***115 kV A1B 'A' Line Protection Upgrade at Aguasabon SS  
Notification of Final Approval of Connection Proposal  
CAA ID Number: 2009-EX454***

## ASSESSMENT SUMMARY

### Aguasabon SS

Plot 1: A1B apparent impedance for L-L-G fault on M23L at Marathon with EWTE =325 MW, LFE = 398 MW

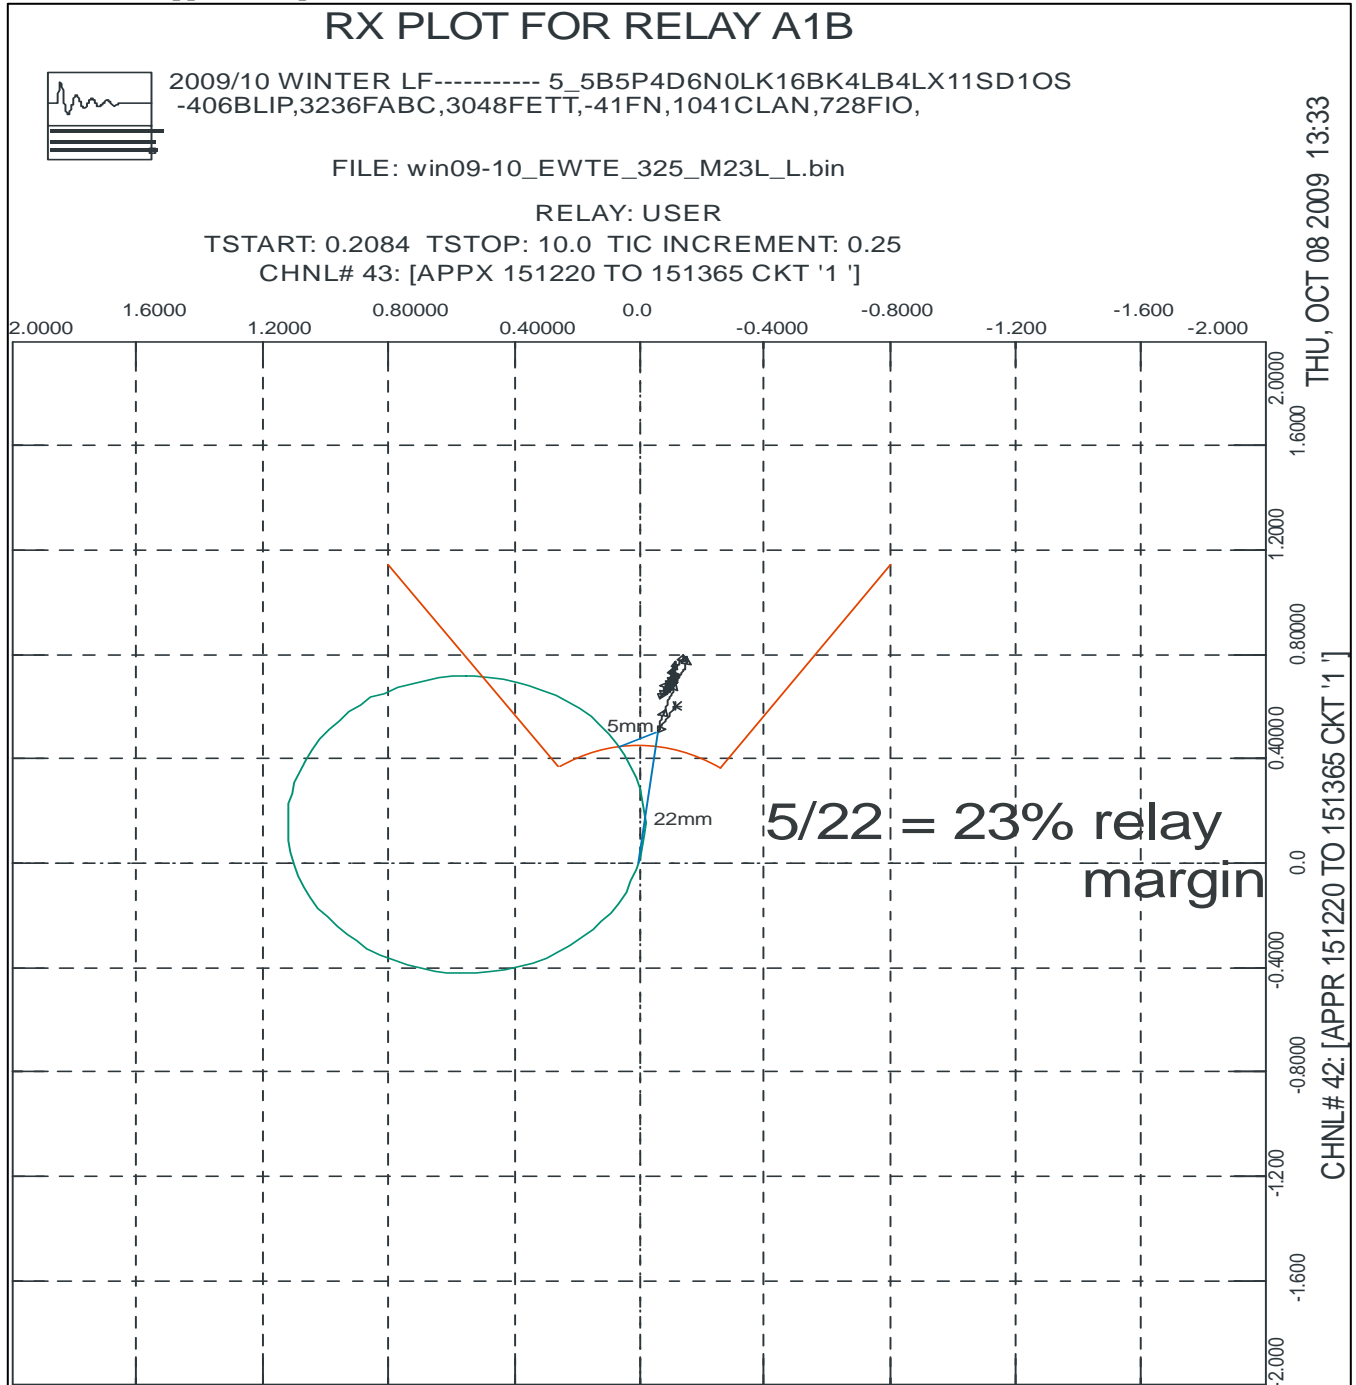
The lowest relay margin of 23% was found under scenario 1 for a phase-phase-ground fault on M23L at Marathon and the relay margin plot is shown below.

The IESO System Operations Manual 7.4, Appendix B, states that “Following fault clearance or the loss of an element without a fault, the margin on all instantaneous and timed distance relays that affect the integrity of the IESO-controlled grid, including generator loss of excitation and out-of-step relaying at major generating stations, must be at least 20 and 10 percent, respectively.”

The zone 3 protection on line A1B is a timed distance relay so the relay margin of 23% is greater than 10% and meets the above requirements.
